AMENDMENT #1 NOTES

ADMINISTRATIVE AMENDMENT
 FILE # 12-10067 PROJECT # 1005498
solar covered parking structures
 APPROVED BY *M. Manone* DATE *6/26/12*

UNIVERSITY OF PHOENIX
 ADULT EDUCATIONAL FACILITY
 BALLOON FIESTA AVE. ALBUQUERQUE, NEW MEXICO

UNIVERSITY OF PHOENIX ALBUQUERQUE CAMPUS CARPORT PHOTOVOLTAIC SYSTEM

A1 SITE PLAN
 SCALE: 1" = 30'-0"

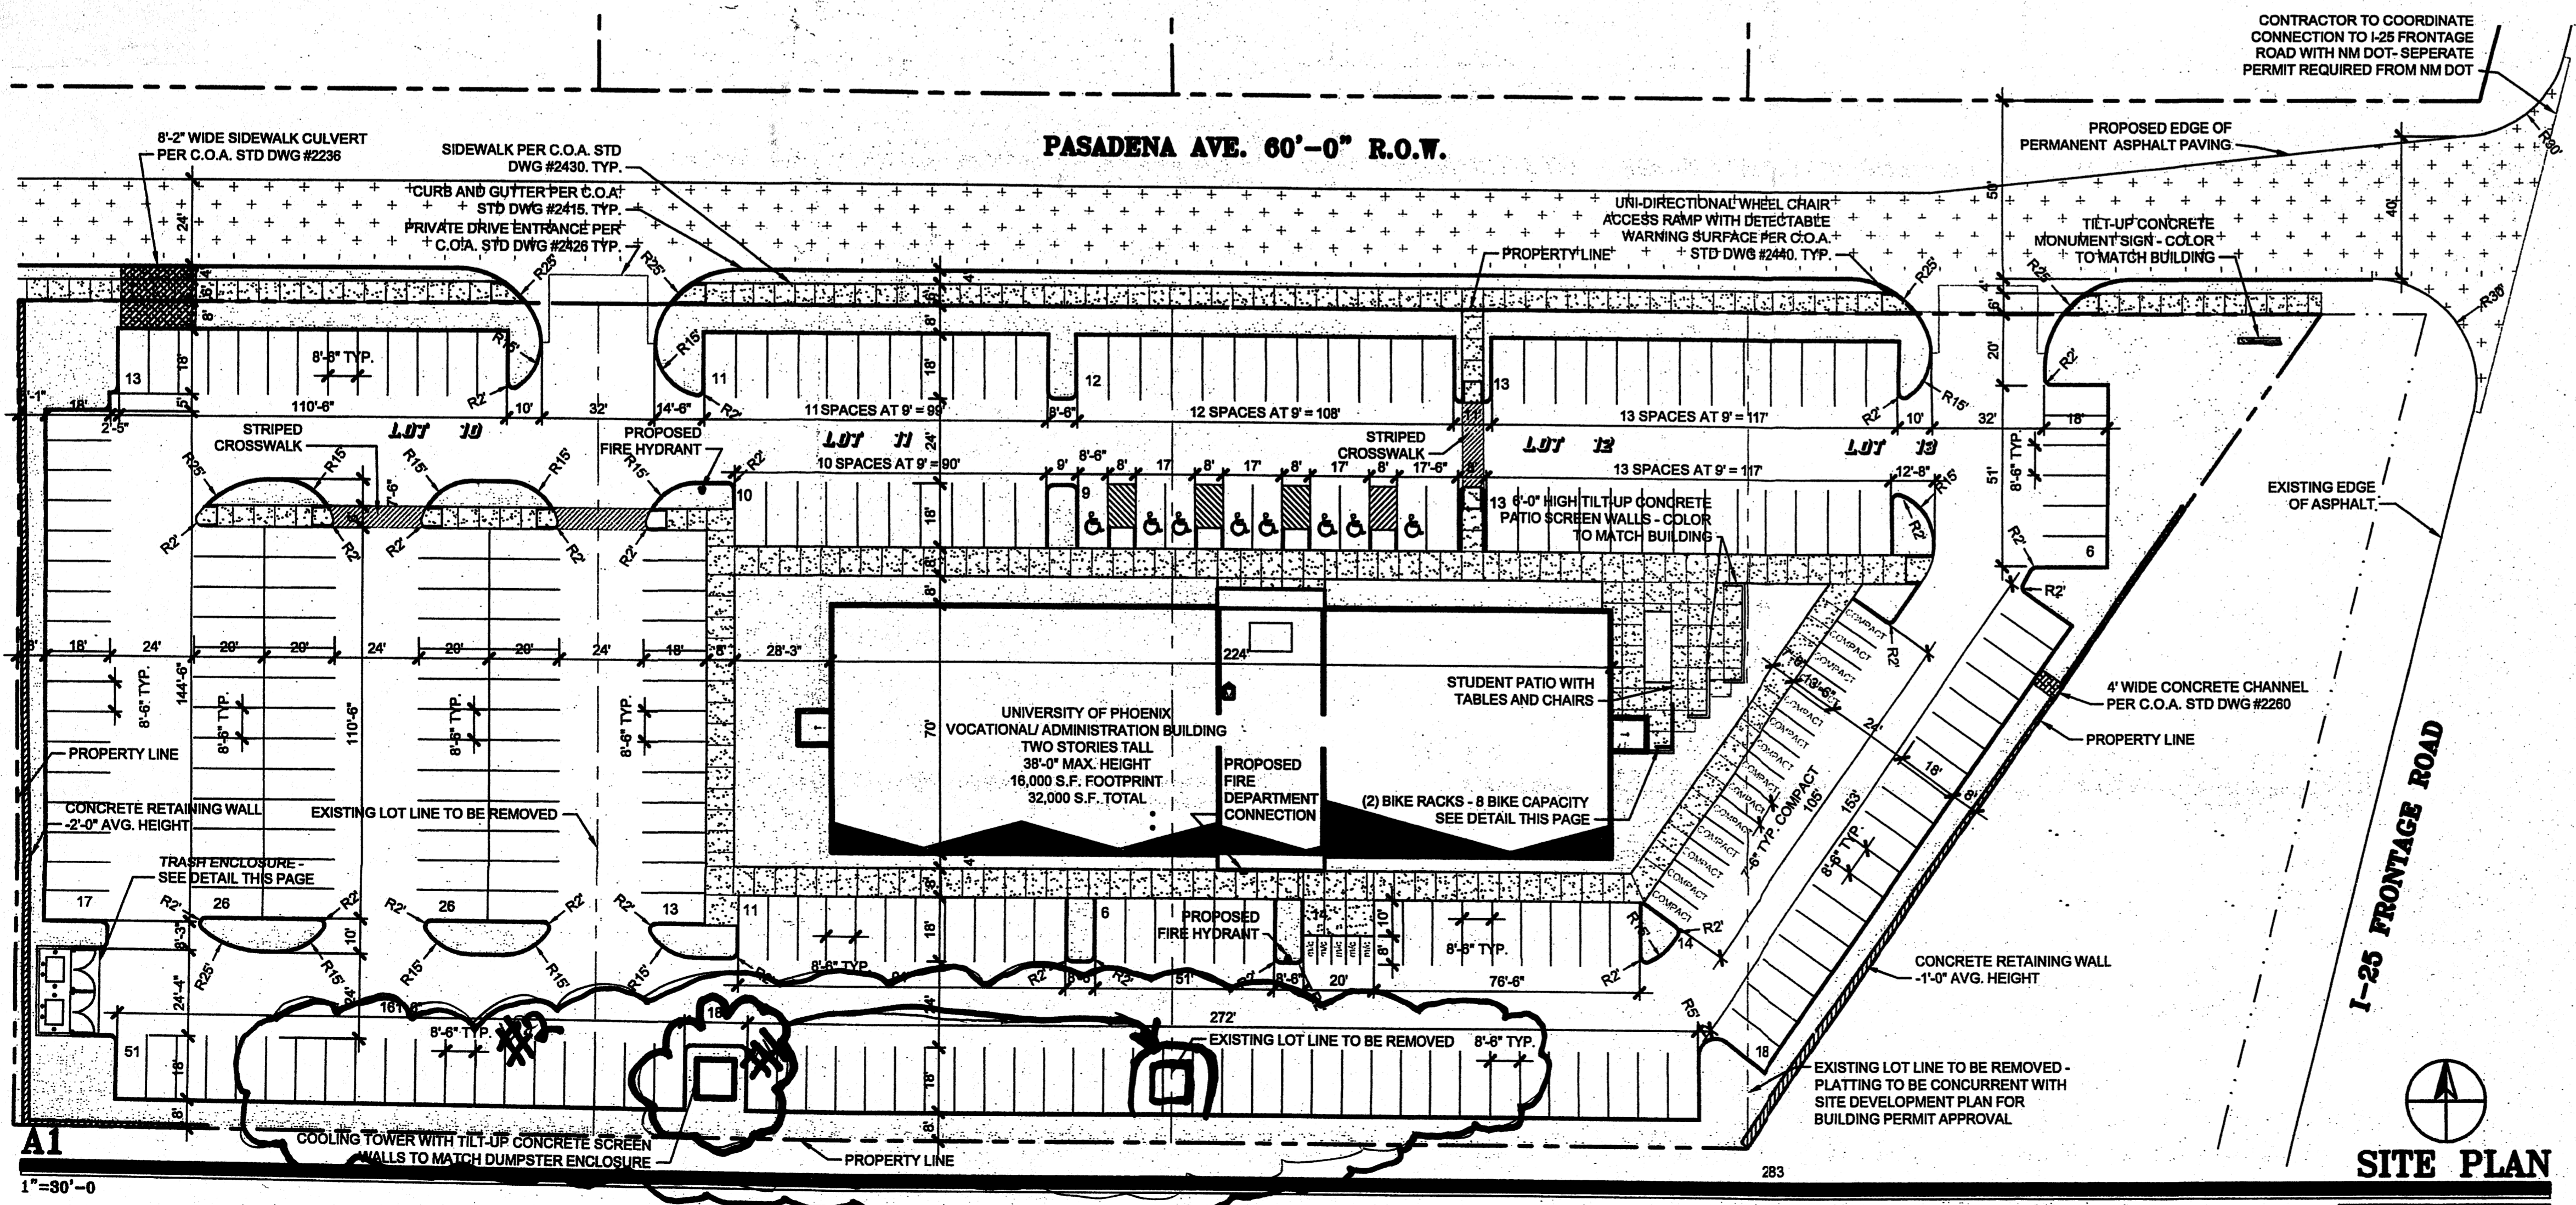
#1: COOLING TOWER ACTUAL LOCATION IS APPROX 150' EAST OF LOCATION INDICATED

#2: NEW SOLAR COVERED PARKING STRUCTURES, CAP PART CANTILEVERED STRUCTURES WITH FOUNDATIONS IN LANDSCAPING.

SHEET TITLE	LANDSCAPE PLAN
SHEET NUMBER	L1

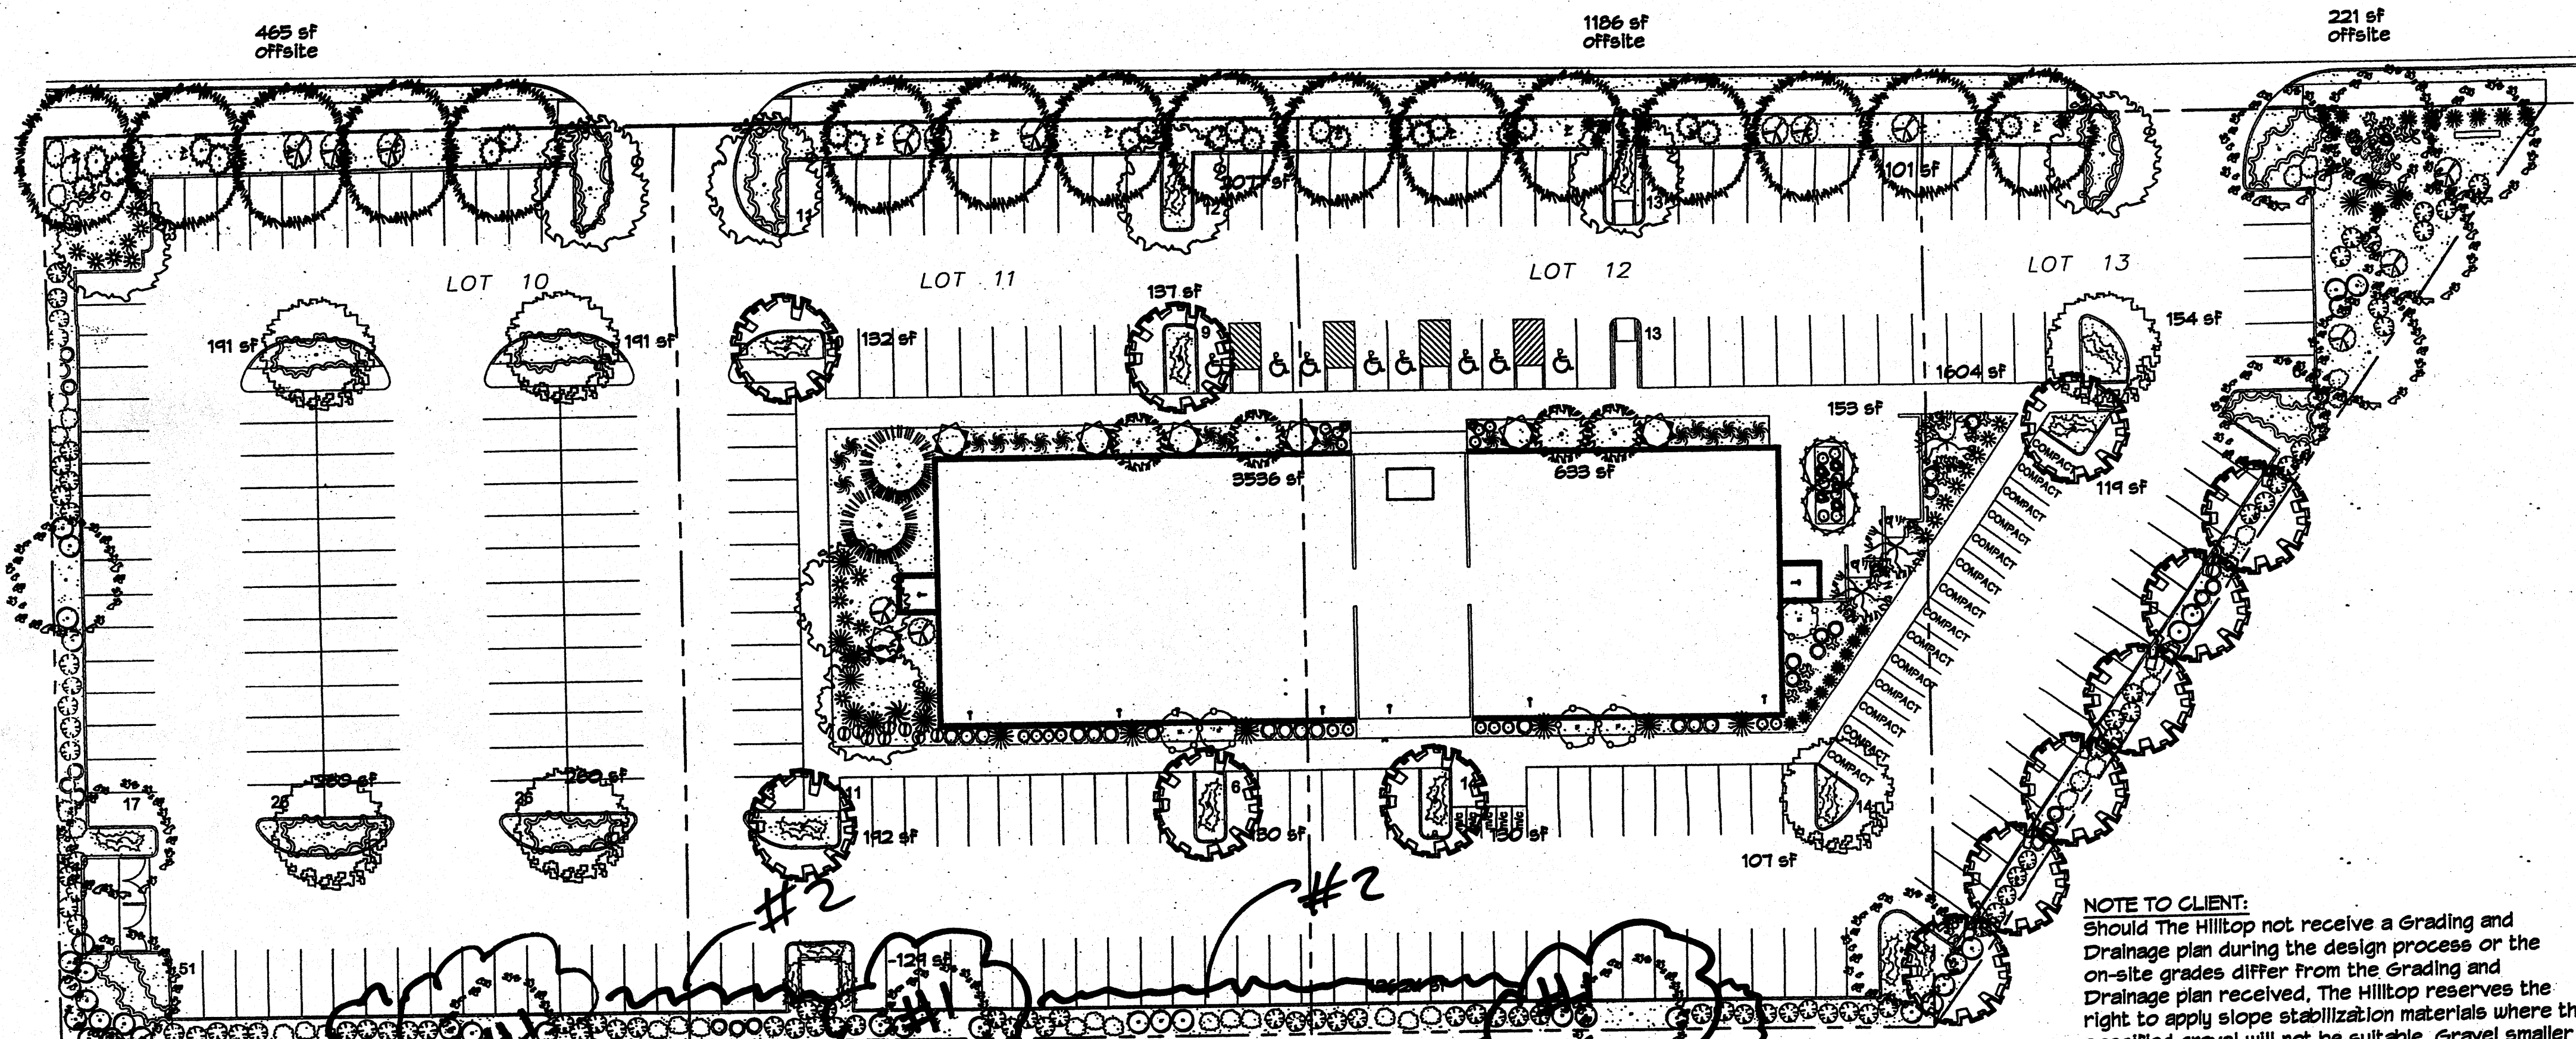
AMENDMENT #1 NOTES

- #1: 3 TREES TO BE REMOVED
- #2: LANDSCAPING AREAS TO BE RESTORED AFTER CONSTRUCTION
